# NORTH SYDNEY COUNCIL REPORTS

# **NSLPP MEETING HELD ON 01/05/24**

**APPLICATION No**: 290/23

PROPOSAL: Alterations and additions to a dwelling in an attached dual

Floor plans (additions in green) showing first floor (left) and roof/attic level (right). Beige-shaded areas form lot 2 in the strata plan.

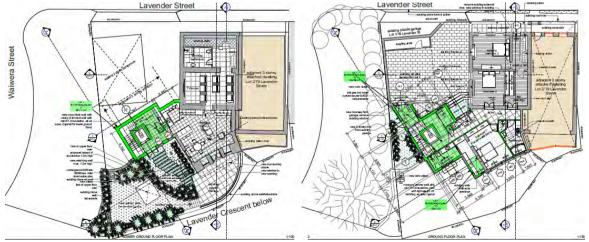
- The filling-in of the balcony on the first floor of the house adds considerable bulk to the southern façade of the building, as does the lift/stairwell extension.

Figure 1: Existing height exceedance in Long Section

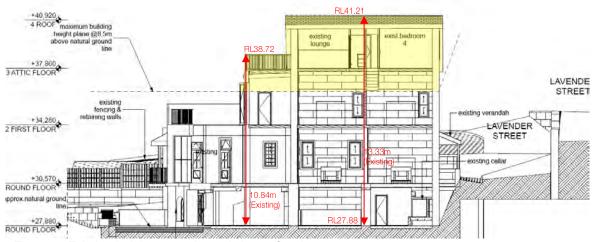
When measured from ground level (existing), the existing dwelling extends to a height of RL41.21, or 13.33m above ground level (existing) which is determined by measuring from the finished level of the existing lower ground floor level at RL27.88. As such, the existing dwelling includes a 4.83m or 56.8% departure to the standard as detailed Figure 1 below.

Figure 3: Proposed height exceedance shaded Blue in Long Section (yellow denotes existing)

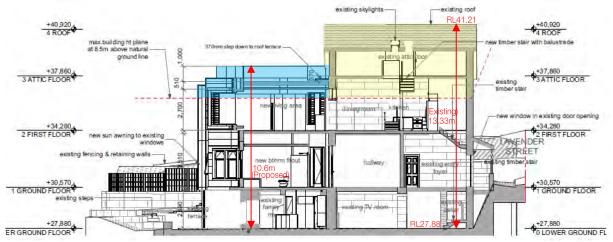
The proposed works will maintain the existing pitched roof form and original elements of the dwelling and seeks to extend the dwelling to the south and west. The proposed additions projects above the maximum building height limit to a maximum building height of 10.6m, resulting in a 2.1m departure and a 24% variation to the Standard. The extent of the proposed additions that project above the 8.5m building height limit at the site are highlighted in blue at Figure 3 below.
